Access Compliance Report

Public Rights-of-Way

(Curb Ramps)

Intersection ID: 2963	Main Street: MADISON_PARK_DR	Cross Street: WHITE_ASPEN_PL	Location: E
ADA ID: D9B697B3589A	Ramp Type: Perp	Initial Pass/Fail: Fail	Overall Compliance: No
Severity Score: 12.5			
Codes/Mitigation Info/Possible Solution		Field Measurements/Component Compliance

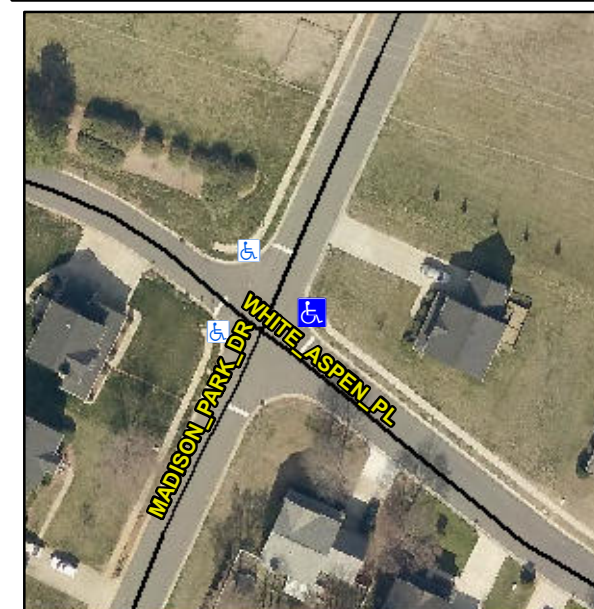
Not Found, R304.5.3

Compliance	Description	Data	Compliance	Description	Data
N/A	Ramp Length (in)	50.0	Yes	Ramp Slope (%)	6.3
Yes	Ramp Width (in)	48.0	No	Ramp XSlope (%)	6.4
N/A	Flare Type LT	N/A	N/A	Flare Type RT	N/A
N/A	Flare Slope LT (%)	N/A	N/A	Flare Slope RT (%)	N/A
N/A	Flare Traversable LT?	N/A	N/A	Flare Traversable RT?	N/A
N/A	Landing Length (in)	N/A	N/A	DWS Provided?	N/A
N/A	Landing Width (in)	N/A	N/A	DWS Contrast?	N/A
N/A	Landing Slope (%)	N/A	N/A	DWS Length (in)	N/A
N/A	Landing X Slope (%)	N/A	N/A	DWS Full Width?	N/A
N/A	Landing Curb? (Y/N)	N/A	N/A	DWS Offset (in)	N/A
N/A	Shared Landing?	N/A			
N/A	Gutter Ponding?	N/A	N/A	Gutter Slope (%)	N/A
N/A	Gutter Lip Ht (in)	N/A	N/A	Gutter X Slope (%)	N/A
N/A	Painted X Walk1?	No	N/A	Painted X Walk2?	N/A
	X Walk 1 Direction	To NW		X Walk 2 Direction	N/A
N/A	X Walk 1 Width (in)	N/A	N/A	X Walk 2 Width (in)	N/A
	X Walk 1 Slope (%)	5.2		X Walk 2 Slope (%)	N/A
	X Walk 1 X Slope (%)	3.6		X Walk 2 X Slope (%)	N/A

Remove & Replace Entire Ramp.
